TECHNICAL BULLETIN
Bell Helicopter **TEXTRON**

No. 222-99-161

MODEL AFFECTED: Model 222/222B

SUBJECT: TAIL ROTOR GEARBOX P/N 222-042-001-007,
-101 AND -103 CONFIGURATION CHANGE
AND UPGRADE

FIGURE 1

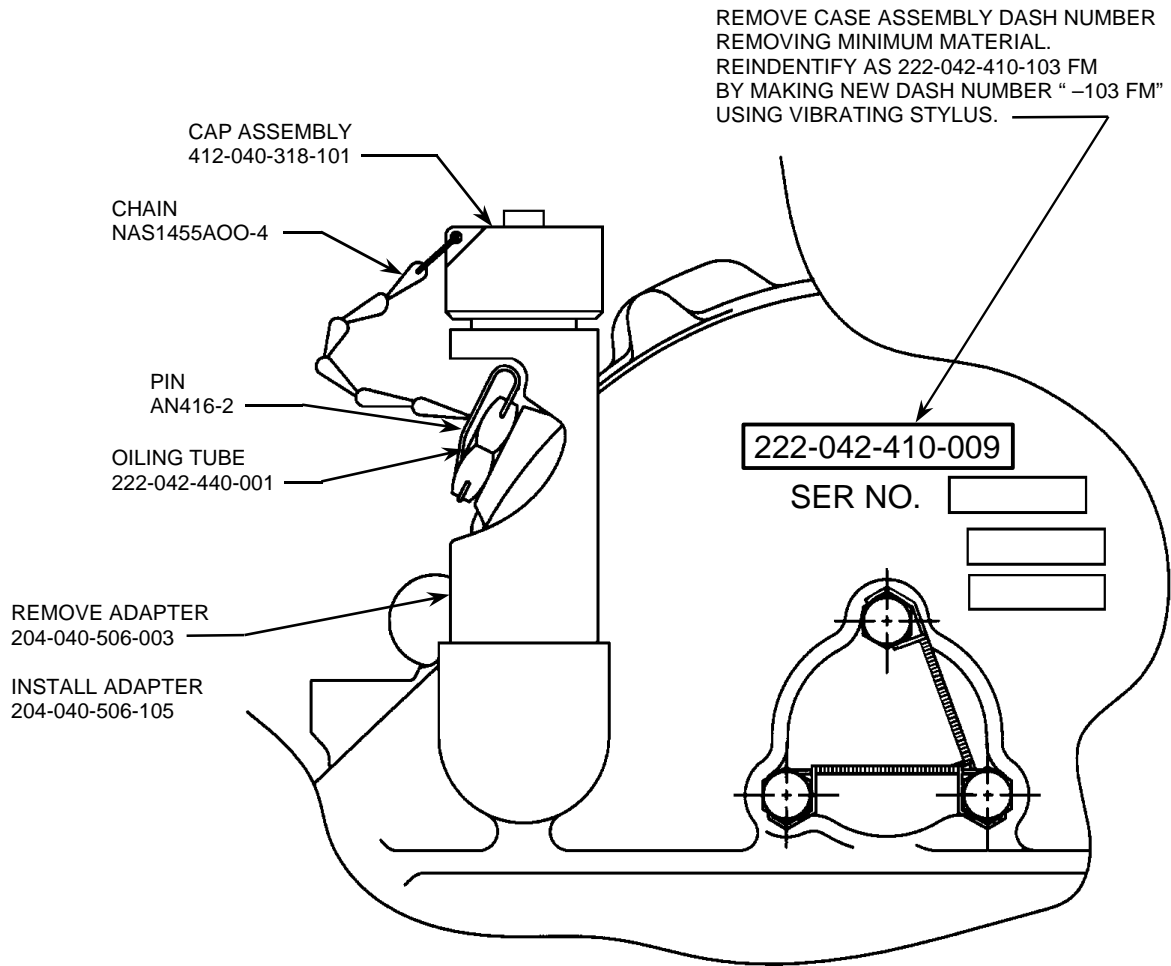
Part I of this bulletin provides information for the modification of 222-042-410-009 tail rotor gearbox case assembly to accept the new oil filler cap assembly P/N 412-040-318-101. This new oil filler cap will improve water exclusion characteristics of all earlier delivered tail rotor gearbox assemblies.

9. Insert new oil filler adapter into case boss.

10. Ensure adapter is fully seated in tail rotor gearbox case. Wipe excess primer from adapter and gearbox case.
11. Using P/N AN416-2 pin, secure chain on oil filler cap assembly P/N 412-040-318-101 to one of the holes in the hex head of P/N 222-042-440-001 oiling tube. Refer to Figure 1.
12. Reidentify tail rotor case assembly 222-042-410-009 as follows:

- a. Remove case assembly -009 dash number by removing minimum material. Reidentify as 222-042-410-103 FM by making new dash number "-103 FM" using vibrating stylus. The serial number of a field modified part will not be altered or changed. Refer to Figure 1.
 - b. Chemical film treat reworked area as per BHT-ALL-SPM, Table C-1, Item B-2. Touch-up using primer (C-204 or C-246) and topcoat using paint (C-245).
 - c. Reidentify case assembly as 222-042-410-103 FM in the historical records.
13. Service tail rotor gearbox. Refer to BHT-222/222B-MM-1.
 14. Install the tail rotor gearbox fairings. Refer to BHT-222/222B-MM-1.
 15. Make entry in the helicopter historical records indicating compliance with PART I of this Technical Bulletin.
